BALTHROP THIRD ADDITION

Wichita, Sedgwick County, Kansas

RE: S/D 99-50 -- One-Step Final Plat of BALTHROP 3RD ADDITION

RE: S/D 99-50 -- One-Step Final Plat of BALTHROP 3RD ADDITION

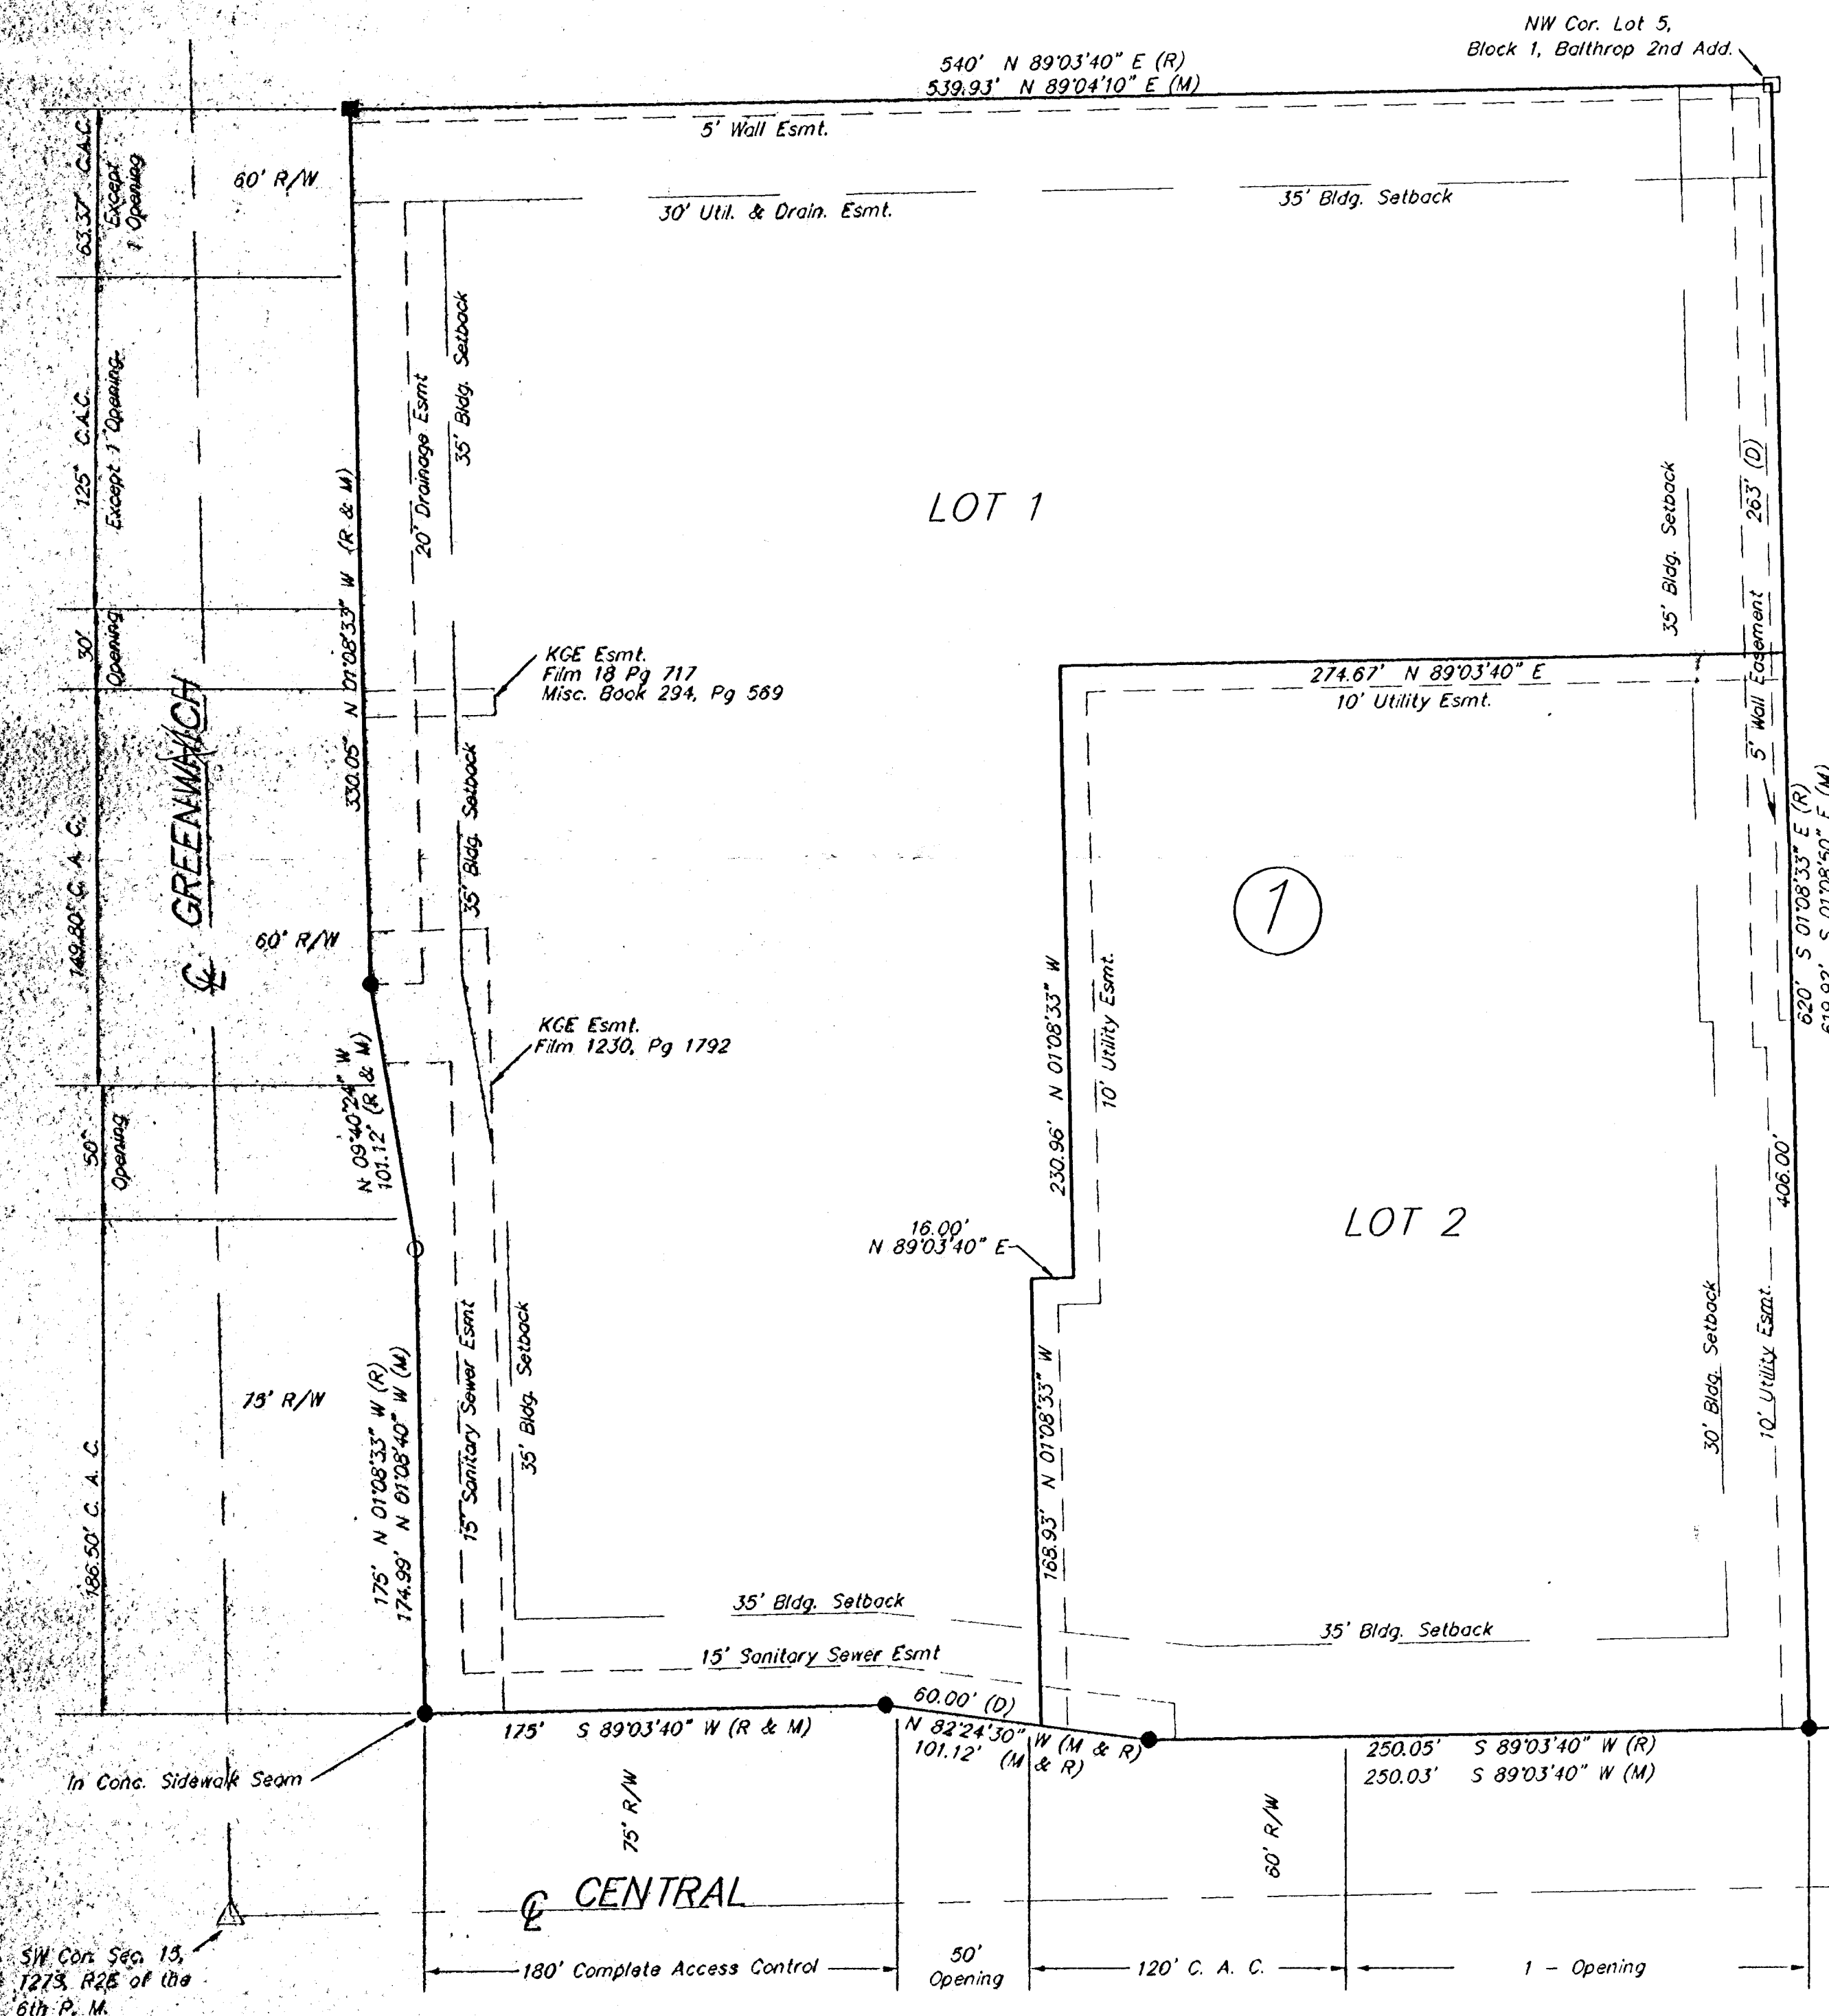
- A. This site is located in the County's Four Mile Creek sewer system and is served by the County. A new sewer petition is required along with a sanitary sewer layout.

- B. City Engineering need to comment on the existing guarantees and the need for providing new or revised guarantees. A guarantee for extension of stormwater sewer is required. A cross-lot drainage agreement and off-site drainage agreement are required.

- D. City Engineering needs to comment on the status of the applicant's drainage plan. A drainage plan has been approved.
- E. Traffic Engineering shall comment on the access controls. Two openings along Central and two openings along Greenwich are permitted for this plat. 125 feet of complete access control is required from the north line of the plat. The westernmost opening along Central is limited to right turns only.

- F. An adjustment to the CUP will be needed to revise parcel boundaries to correspond with the platted lots.
- G. Since this is a replat of a previous Addition involved with the ownership and maintenance of reserves which are not being replatted by this Addition, a restrictive covenant shall be

- H. An adjustment to the CUP will be needed for any revisions in the access controls.
- I. On the final plat tracing, a note shall be placed on the face of the plat indicating that this Addition is subject to the conditions of Community Unit Plan DP-232.

- J. The platator's text shall include language that a drainage plan has been developed for the plat and that all drainage easements, rights-of-way, or reserves shall remain at established grades or as modified with the approval of the applicable City or County Engineer, and unobstructed to allow for the conveyance of stormwater.

- R. The representatives from the utility companies should be prepared to comment on the need for any additional utility easements to be platted on this property. *Southwestern Bell has requested additional easements.*
